CAA Operational Assessment

Title of airspace change proposal	Swanwick Airspace Improvement Programme - Airspace Deployment 6 (SAIP AD6)
Change sponsors	NATS En Route Ltd (NERL)/London Luton Airport Operations Ltd (LLA) (EGGW) – The Sponsors
Project reference	ACP 2018 - 65
Account Manager	██████████

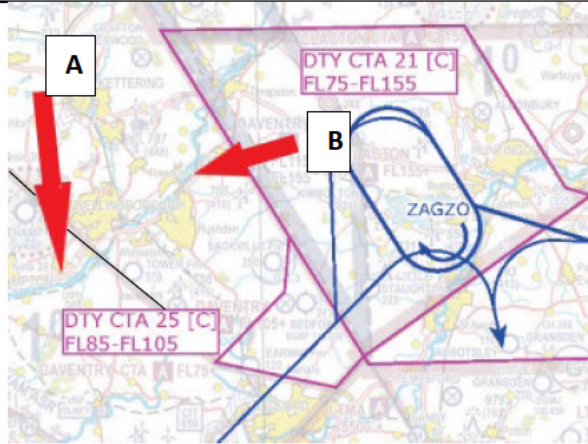
B.11	Is there assurance, as far as practicable, against unauthorised incursions? (This is usually done through the classification and promulgation.)	YES
<p>Yes; the Sponsors have proposed the minimum volume of CAS in order to provide containment for the revised STARs and new hold. In the picture below (Fig 1) the Sponsors have proposed a 'ledge' design to the airspace, which is different from what was proposed in the consultation. The Design Principle (DP) 15 should have ensured that the airspace construct was 'simple', in order to reduce the risk of infringements. This DP also had to balance with the need for a safe airspace design in terms of containment and minimising the required volume. The proposed shape is considered to be acceptable, despite the introduction of an extra side to the shape, as it is the minimum size required for containment of a procedure and the risk of infringement by non-participating aircraft (outside CAS) is mitigated due the proposed base-level being at FL125 (see Fig 1 below).</p> <p>In Figure 2 below arrow A is to show that Class G airspace south of the black line is surface to FL75. The airspace between the blackline western edge of DTY CTA 21 as shown by arrow B is Class G from surface to FL105. This proposal will create a 3000ft 'hump' of Class G airspace, approximately 8 miles wide. This is acceptable as the hold position had to take into consideration the current northerly flows of aircraft west of the proposed DTY CTA21. No 78 Sqn RAF Swanwick Mil have a radar corridor (the DTY RC) that passes through this portion of class G at FL110 (FL100 on occasion). No 78 Sqn RAF Swanwick Mil have a draft LoA in place with the NATS in order to address any issues regarding aircraft passing through this area of class G and are aware of the implications. The Sponsors have not highlighted that they perceive there is any increased risk of airspace incursions as result of this airspace proposal.</p>  <p>Fig 1.</p>
